RE: PL2024073: Residential Preliminary Development Plan for Cobey Creek

OWN, Inc. has received the City Staff comments dated April 08th, 2024 and have the following responses:

RE: PL2024073: Cobey Creek Preliminary Development Plan Narrative

MODOT HWY 150 WIDENING 2023-04-07.pdf

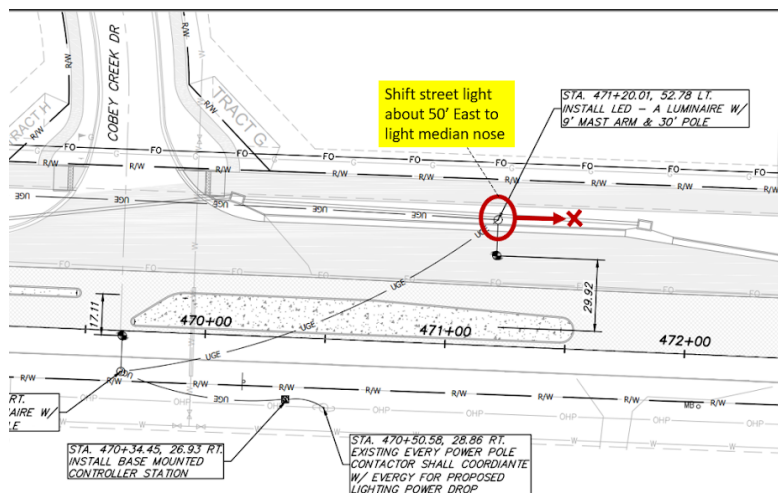
I hate to seem nitpicky but I did notice on page 16 that the light for the western nose should be lined up adjacent to the nose so that it doesn't cast a shadow, as shown below.

Chris, yes that is a good comment. We have addressed that in these plans and revised sheet #16 to reflect a relocation of the appropriate light pole.
